## **A vision for conservation and public enjoyment of the Greater Brixton Street Wetlands and an eventual Yule Brook Regional Park**

**This document is a Statement of The Beeliar Group – Professors for Environmental Responsibility.** It presents and argues in more detail themes introduced in the Group's 2017 Statement *The Greater Brixton Street Wetlands/Bush Forever 387: Causes for concern related to the Maddington-Kenwick Strategic Employment Area*, and presents its vision for a Yule Brook Regional Park based on the Greater Brixton Street Wetlands, and Yule Brook and its floodplain. It argues the case for a beneficial coexistence of the Maddington Kenwick Strategic Employment Area (MKSEA) with the globally-unique natural values of the Yule Brook Regional Park, provided that basic principles of conservation of the adjoining natural environments are followed in the MKSEA development.

**Figure 1: Greater Brixton St Wetlands, the Yule Brook and the MKSEA**

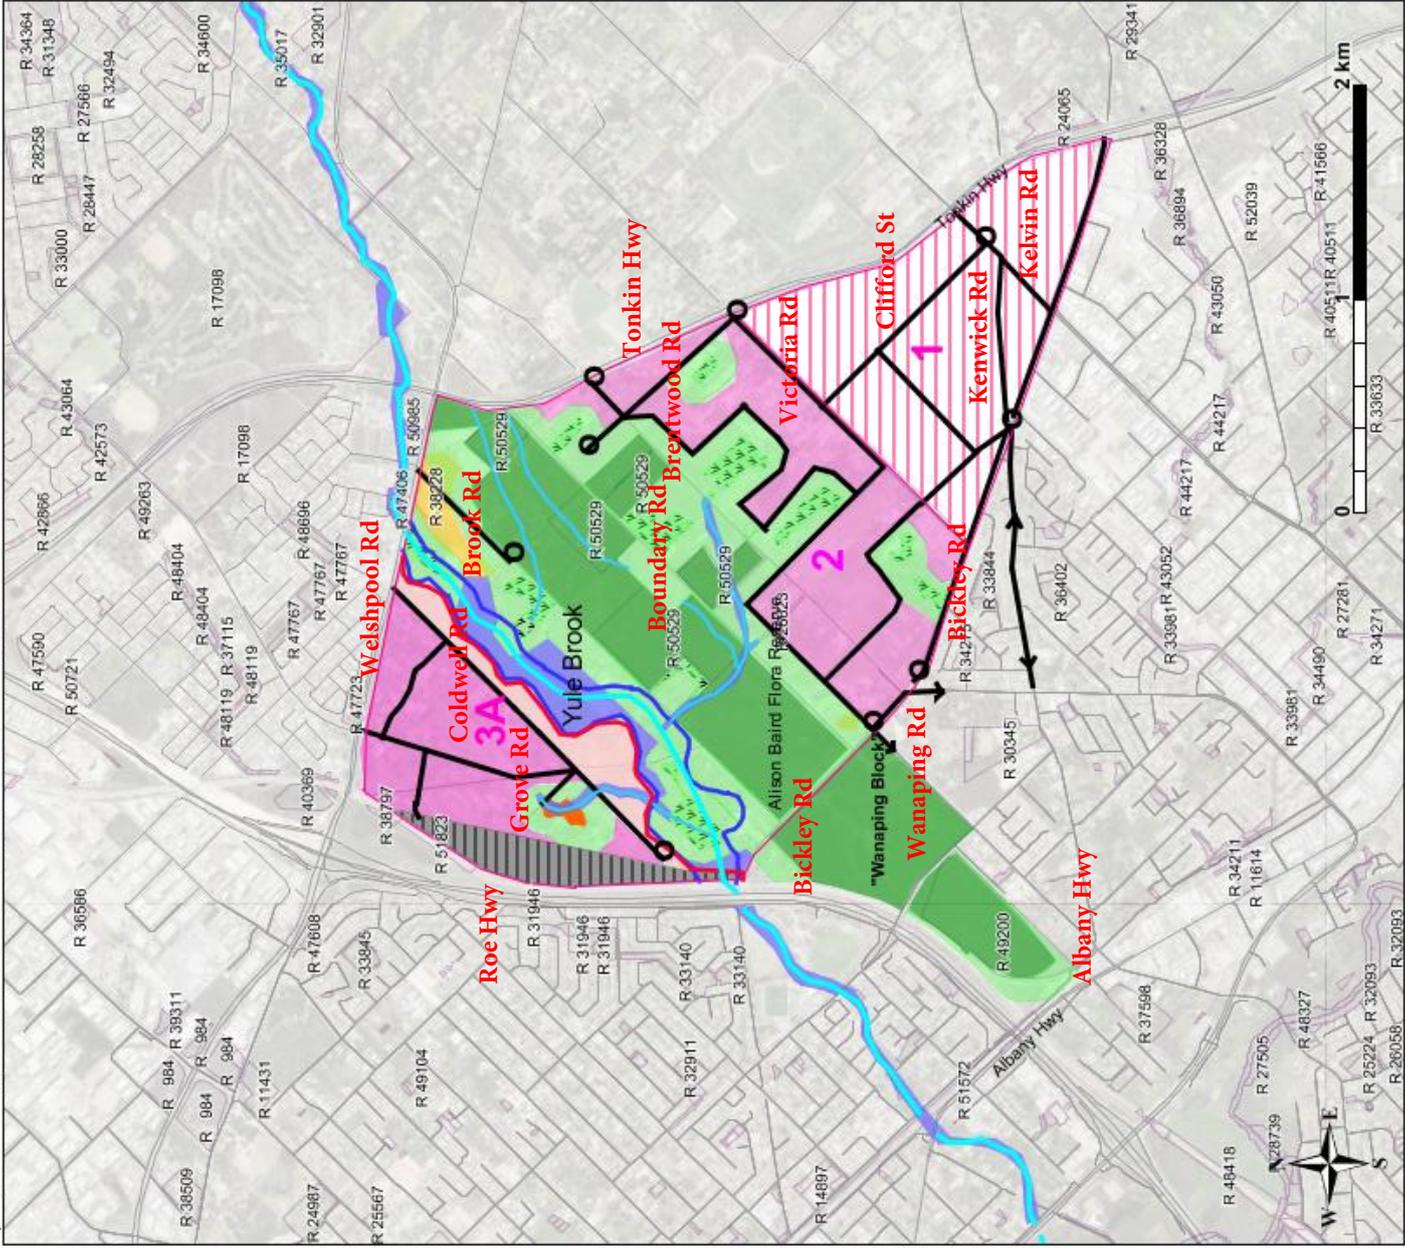
Without adequate stratigraphic and hydrological data and mapping, a minimum 100 metres buffer around all CCWs and TECs in the GBSW and the MKSEA and the riparian vegetation of Yule Brook (**Figure 1**) is required as a precautionary measure to support the hydrological maintenance of the wetlands. This approach is in accord with the Guideline for the Determination of Wetland Buffer requirements (WAPC, 2005). This Guideline specifies an ordered and scientific approach to: first, determine and accurately map the Wetland Function Area; second, to identify the role that separation from adjacent land uses (e.g. industry, roads and drainage infrastructure) plays in the protection of the wetland; and finally, to determine an appropriate width Separation Distance (buffer) between a wetland and the adjacent land uses.

The creation of a managed vegetation, Public Open Space area along the Yule Brook side of Coldwell Rd (Figure 1) will enable the planning of Separation Areas that protect both industrial buildings and the native or restored vegetation of the MKSEA, the GBSW and Yule Brook. There are also building standards solutions to these issues, under AS 3959 (Standards Australia, 2009), that could protect both the natural and the built environments.

These environmental and non-environmental impacts of the MKSEA road system can be addressed by the following actions (Figure 1).

1. Reservation, as detailed above under “Ecological buffers”, of 100 metres buffers around all of the GBSW and the TECs identified in the MKSEA to link these TECs to the GBSW. This action would require the closure or relocation of Boundary Rd and parts of Brentwood Rd.

2. Closure of Brook Rd from the City of Gosnells boundary to Bickley Rd to provide direct ecological linkage between Yule Brook and the GBSW.
3. Closure of Grove Rd south of Coldwell Rd and of Bickley Rd from Brook Rd to Wanaping Rd so that MKSEA and other traffic does not use the Bickley Rd/Grove Rd linkage as a rat-run, with increased traffic across Yule Brook and the core conservation areas of the GBSW. These closures would also benefit residents of parts of Kenwick and Beckenham (which could otherwise be accessed by heavy Precinct 3A traffic by way of Wanaping Rd and Brixton St) and reduce the volume of MKSEA traffic entering the highly-congested Albany Highway.
